LTR-NRC-11-42

Subject: Responses to Requests for Additional Information on 6002-00301, CS Innovations' "Advanced Logic System Topical Report"

**Responses to Requests for Additional Information (RAIs) on 6002-00301, CS Innovations'
"Advanced Logic System Topical Report"
(IC-11-106)**

Figure 6-1 Temperature Versus Humidity - Enclosed Environments Outside Containment

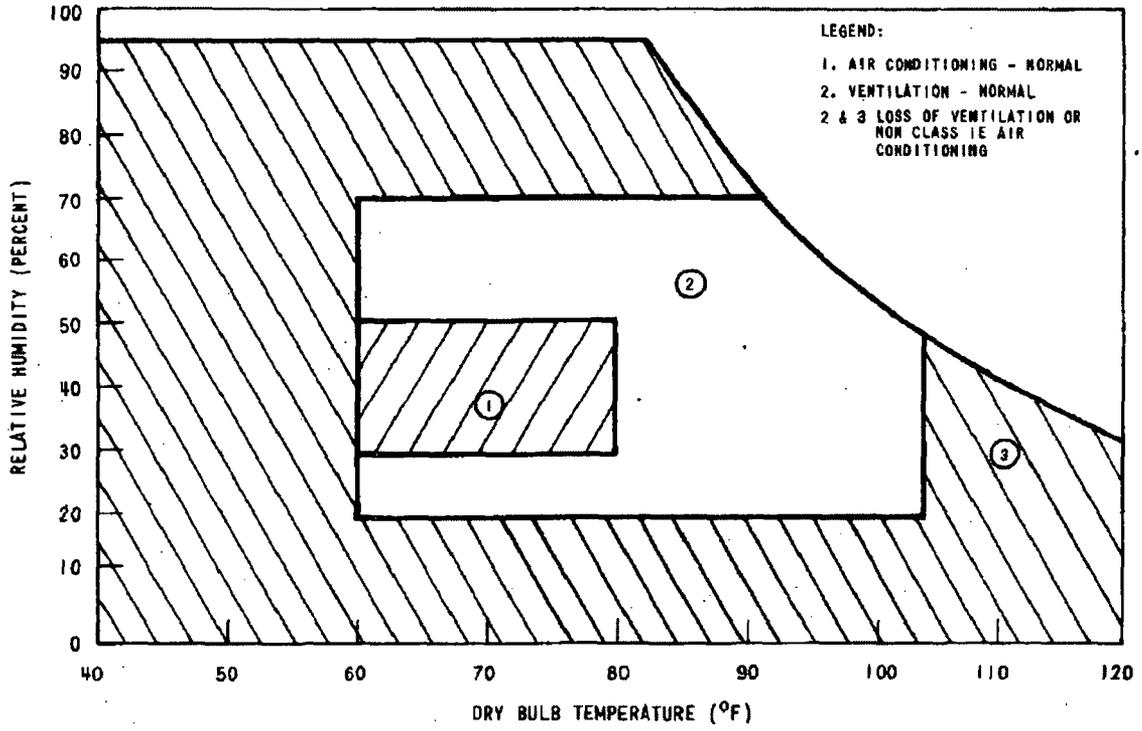
Describe how the combination of environmental conditions that are represented in the environmental profile of Advanced Logic System (ALS) EQ Plan (Section 5) and the ALS Topical Report (Section 4.1.1) and the limits identified in ALS Topical Report and the ALS Platform Requirements Specification (Section 9.1) sufficiently envelope the ALS Platform's susceptibility to synergistic effects from the proposed service conditions. This description should address Regulatory Guide 1.209 Regulatory Position 1 and Digital I&C-ISG-06 Section D.5.4.1.

The ALS Platform follows the standard Westinghouse Equipment Qualification methodology for qualifying safety grade equipment as documented in the NRC approved WCAP-8587, revision 6-A. The postulated worst case abnormal temperature and humidity conditions are based on Table 6-1 (reproduced below) for equipment located outside of containment in mild environments. Figure 6-1 (reproduced below) also illustrates the abnormal temperature and humidity conditions. As required by Regulatory Guide 1.209, the test conditions will simulate the actual abnormal environments and durations given in the Table.

To address synergistic affects, the environmental conditions of temperature, humidity, voltage and frequency are applied simultaneously to the equipment under test. Performance of the equipment and its ability to perform its safety function are demonstrated under these extremes. Any additional synergistic effects resulting from future service conditions will have to be evaluated when they are made available.

Qualification is performed to envelop the anticipated operating environments. The environmental requirements in the ALS Platform Requirement Specification are not the basis used to develop environmental qualification testing profiles.
